MEMORANDUM

To: Design Review Board
From: Jon Regala, Senior Planner
Date: January 7, 2013
File No.: DRV12-00921
Subject: LAKE STREET PLACE - DESIGN RESPONSE CONFERENCE
(CONTINUED FROM DECEMBER 17, 2012)

Response to December 17th Design Response Conference:

PHASE I

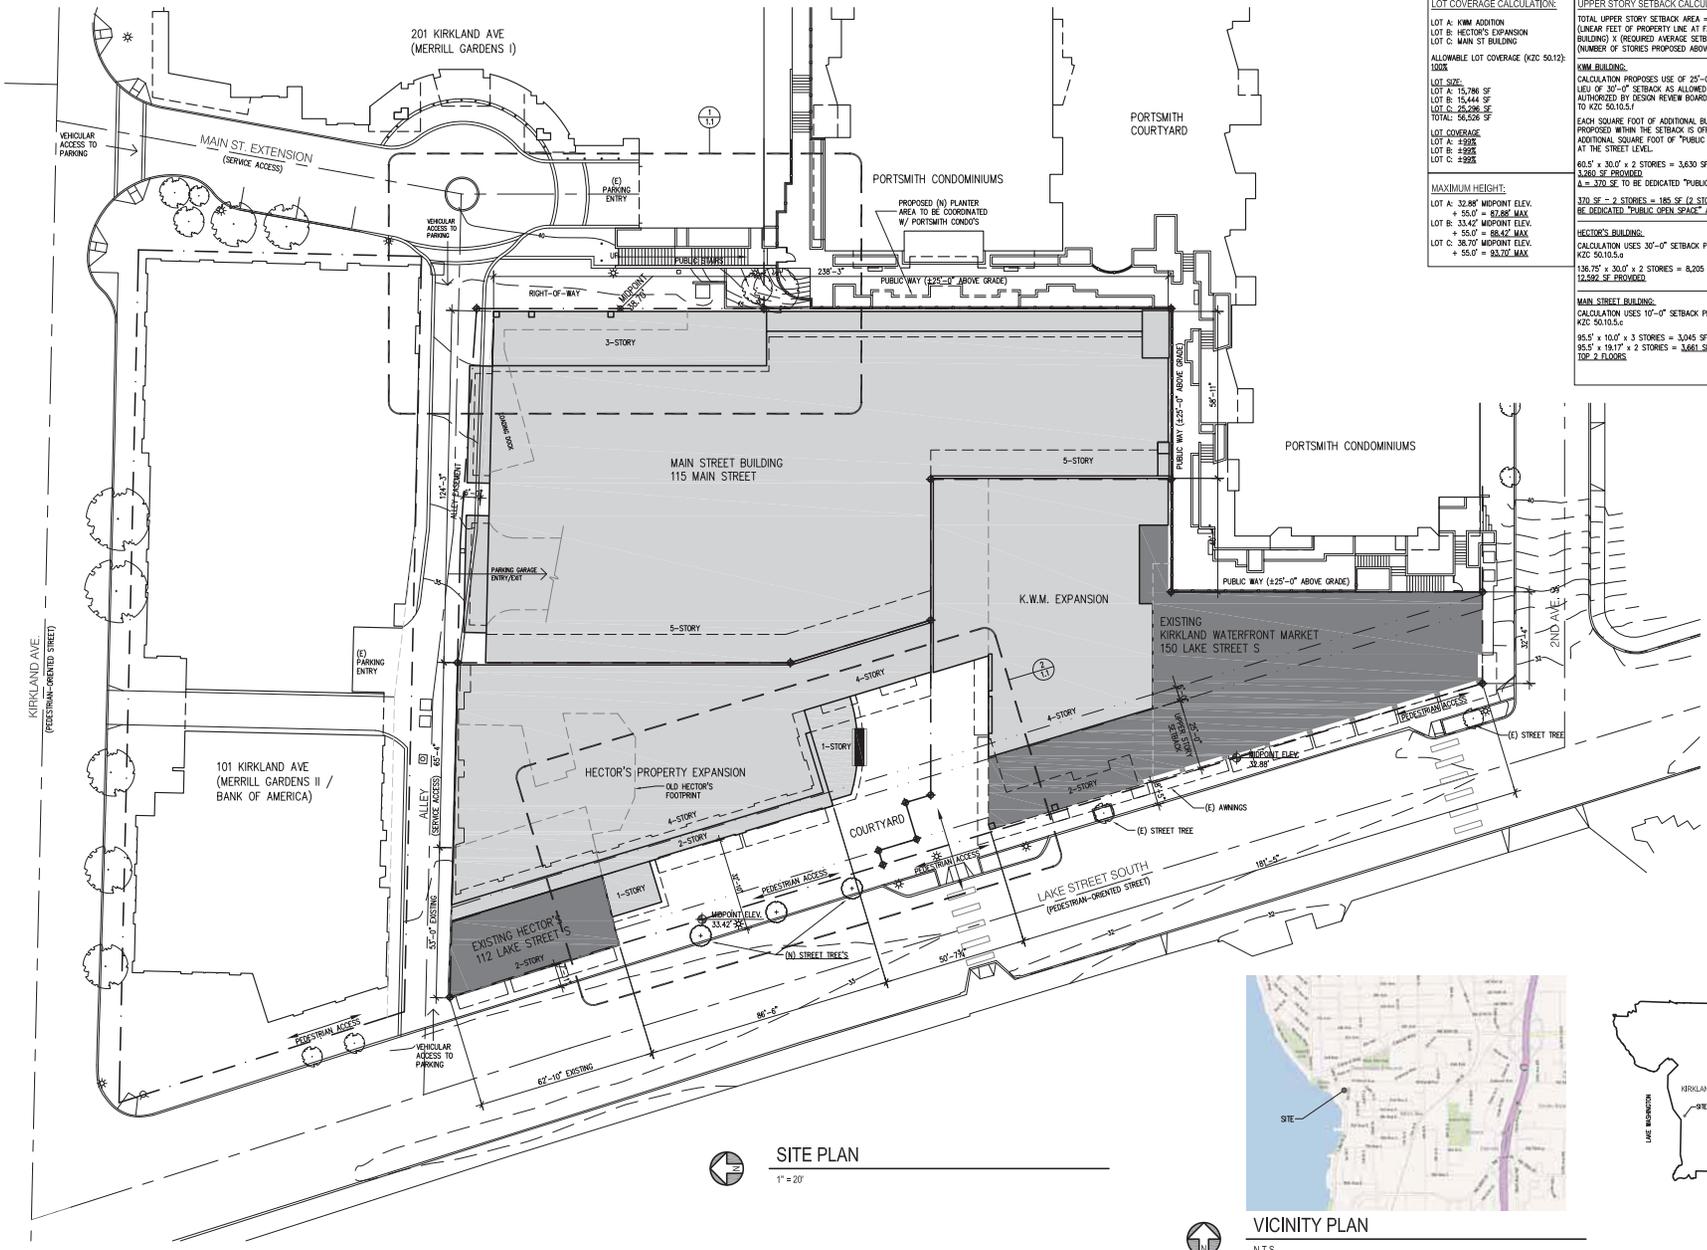
1. DRB Recommendation. The DRB requested that the applicant provide additional information regarding Phase I of the Lake Street Place project. Phase I consists of an expansion to the Milagro Restaurant and a two-story office addition atop the Kirkland Waterfront Market. The DRB wanted to review how Phase I would look prior to the construction of the remainder of the project, especially the north and east facades.

2. Staff Comment. The DRB should review Phase I for consistency with the Design Guidelines and provide feedback to the applicant for recommended changes. Staff is concerned that the north and east façades are not consistent with the Design Guidelines. Since the remainder of the Lake Street Place project is dependent on pre-leasing, it is possible that the remainder of the project may not be constructed leaving the north and east facades exposed. Therefore, it is important that Phase I be consistent with the Design Guidelines.

- As shown on sheet 6.0 the first phase of the project is the 2 story addition above the existing north wing of the Kirkland Waterfront Market (KWM). As noted in the project description Lot A: The Kirkland Waterfront Market (KWM) building is proposed to add two new floors above the northern portion of the existing building and a 20ft wide 4 story addition to the north side of the existing building. This new space will provide an additional 950 sf of restaurant space at the first level and an additional 13,400 sf of office space above the first and second floor levels.

- The South and West facades show the glass fenestrations that have been reviewed with the Lake Street proposal.
- The North perspective shows a first level fabric awning at the northeast entrance to the stairs and elevator. The first level also shows retractable “Nana” doors that open to an interior banquet room.

- The North façade shows a scored exterior plaster at the top three floor levels. The color and scoring pattern match the existing north facades of the existing KWM building.

- The East façade shows a scored exterior plaster.
- The exterior plaster scoring pattern for the north and east facades is developed by the similar horizontal and vertical patterns shown on the south and west facades.

OVERALL LANDSCAPE PLAN

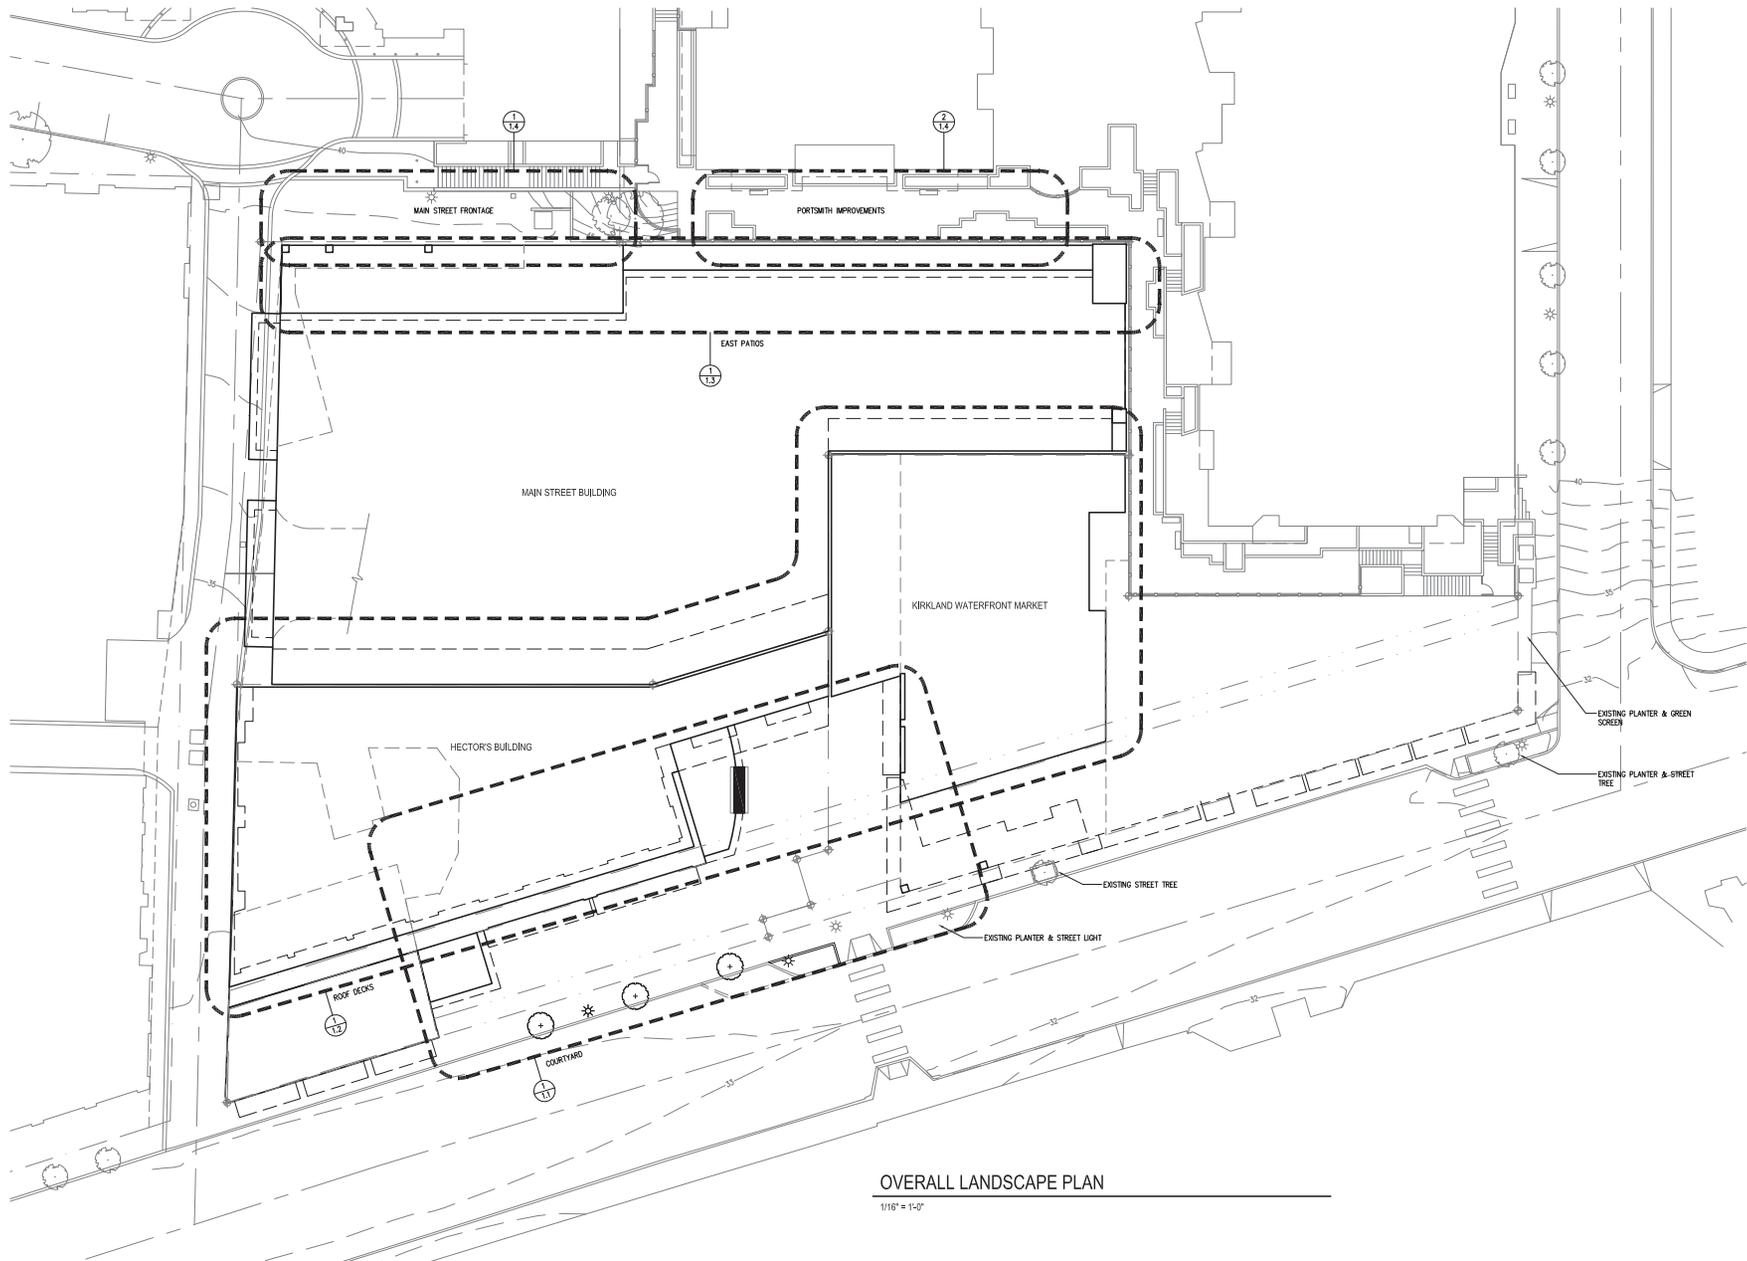
1. DRB Recommendation. In general, the DRB liked the landscape, paving, and, lighting plan proposed by the applicant. The DRB requested the following changes:

- The paving pattern within the courtyard area should flow with the 'L' shape of the courtyard.
- The landscape plan should be revised to contain more diversity in the plant selection (less use of azaleas and grasses) and to include species that would provide year round interest.

- Replace the railing delineating the outdoor seating area with a more moveable boundary consisting of benches and planters.
2. Staff Comment. The applicant submitted a landscape and lighting plan with the recent revisions (see Attachment 3, Sheets L1.0 to L1.4). These plans also include the sidewalk details along Lake Street and the courtyard area. The DRB should review the landscape and lighting plan at the meeting. The DRB should also provide feedback on the sidewalk configuration shown on Sheet L1.1.

- As shown on sheet L1.1 we pulled the 12” wide concrete border to the north and midway through the sidewalk area long Lake Street. The new border and concrete paver infill extends to the north and flows more with the L-shaped courtyard.
- As shown on sheet L1.1 the outdoor seating areas are bordered by benches and moveable planters rather than a continuous railing. We plan to use different sizes of planters with seasonal mixes of annuals together with plants such as- Japanese Maples, Magnolia Grandiflora, “Portugal Laurel”, “Mexican feather grass”, and “Heavenly Bamboo”.
- As shown on landscape sheets L1.2 through L1.4 we plan to use a more diverse use of plants in the planter areas. The plans show more seasonal and year round plants and less Azaleas and grasses.
